Subject: *Discoverer Enterprise*
Reference: Acceptance of Well Control Equipment

WEST Report #3925

Section 1: Project Summary

Section 3: WEST Recommendation Summary and Disposition
Discoverer Enterprise, Job #3925; 27 April to 16 May 2010
Prepared for BP

Figure 1: Damaged moonpool Coflexip type hoses

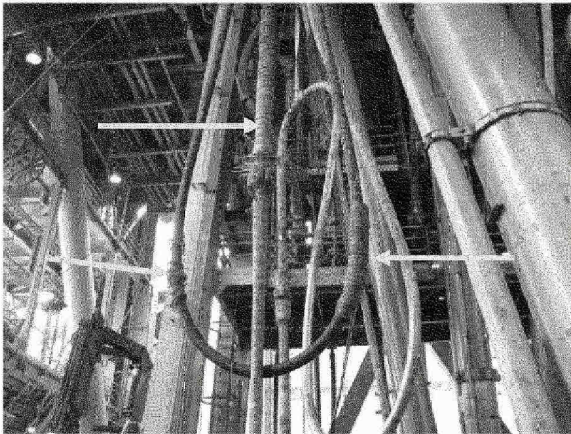
The Coflexip type hoses in the moonpool were visually inspected. All hoses in the moonpool were observed to have damage to the outer protective sheath, and will need to be replaced. It was also noted that the moonpool hoses did not have safety slings installed. Safety slings should be installed from the rig hard piping to the Coflexip type hoses. Reference IADC Safety Alert 00-24. See Figures 1 and 2.

Figure 3: Damaged riser buoyancy thrust collar.

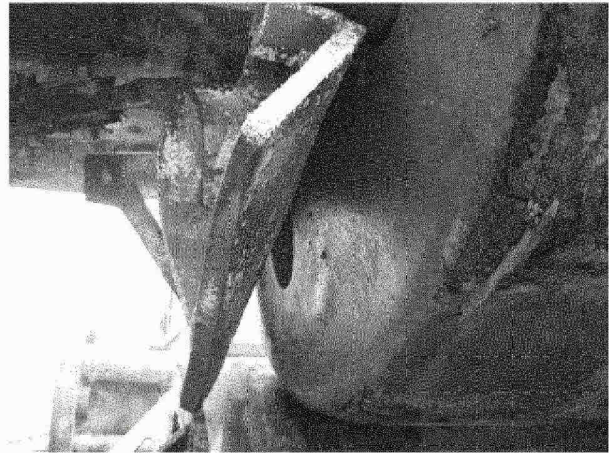
Several buoyancy modules were observed to be damaged; these damaged modules should be repaired. See Figure 3.

Figure 4.1. Shows the HP Casing Shear Close SPM with broken arbor spring.

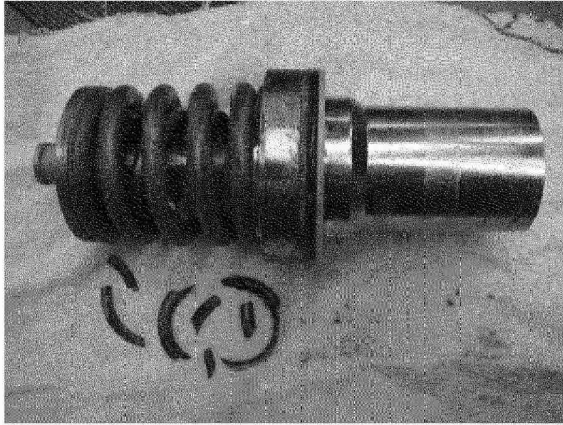
A replacement spring was sourced and subsequently fitted to the valve assembly. Further testing of the EDS is ongoing and will be documented in the next daily report. See Figures 4.1 and 4.2.

Figure 4.3: The yellow arrow shows the HC Collet Connector secondary unlatching cylinder, the two circles show the secondary piston seals, one of these two (or both) seals has failed causing operating fluid to migrate upward into the primary unlocking cylinder area, shown with the green arrow.

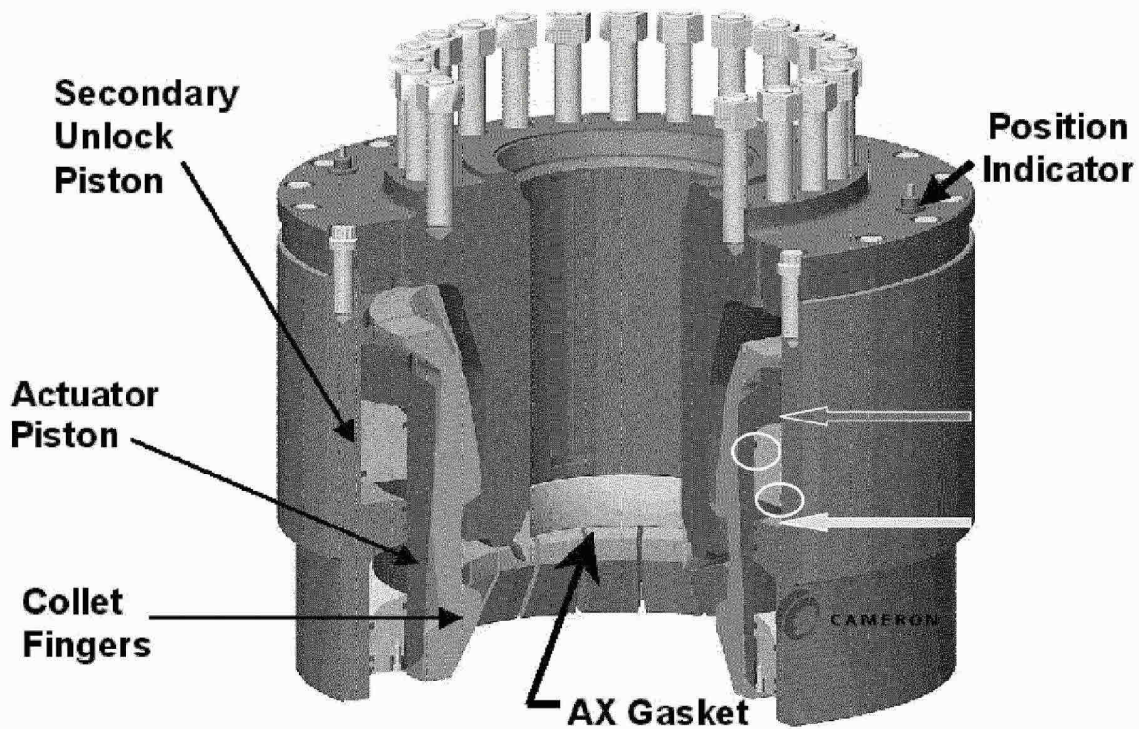
Figure 4.3 refers to the Cameron HC Collet Connector delivered to the rig to be fitted into the wellhead connector position.

Prior to fitting the connector had operator pressure tests carried out to determine the integrity of the hydraulic circuits. The primary lock circuit and primary unlock circuit's were both successfully tested to 3,000 psi /10minutes. The secondary unlock circuit could not be tested and was found to be communicating with the primary unlock circuit, fluid was visible leaking back through the primary port at the connector head. The leak was witnessed by WEST and Transocean, pressure testing was suspended awaiting a response from the OEM and Transocean management.

Figure 5.2: Shows the HC Connector prior to disassembly.

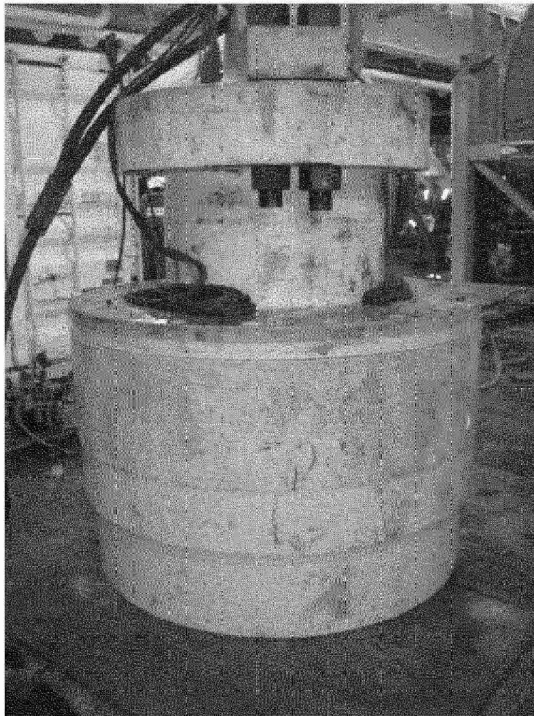
The Cameron HC Collet connector was removed from the set back area and prepared to be disassembled by the OEM, Cameron (See Figure 5.2). The body center section was removed from the body, while removing the center section, the collet cluster was fixed to the center section hub by way of cargo straps (See Figure 5.3). This will enable the connector to be rebuilt faster and with less manual handling of the collets while rebuilding. Further dismantling and inspection will be ongoing.

Figure 17.1 Casing shear ram operator bolts to be replaced.

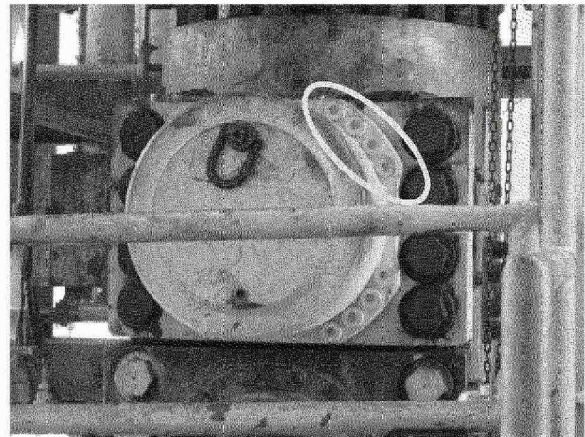
The workscope for tonight is to replace the 16 each forward casing shear ram operator bolts as per Hydril Advisory 09-001. See Figure 17.1. and Attachment A. Once the new bolts are installed the bolts will be torqued to 1,700 ft/lbs using Moly 503 lubricant. The bolts are 1-1/2" x 5-1/2", Hex head, Xylan coated and Inconel 718 precipitation hardened.
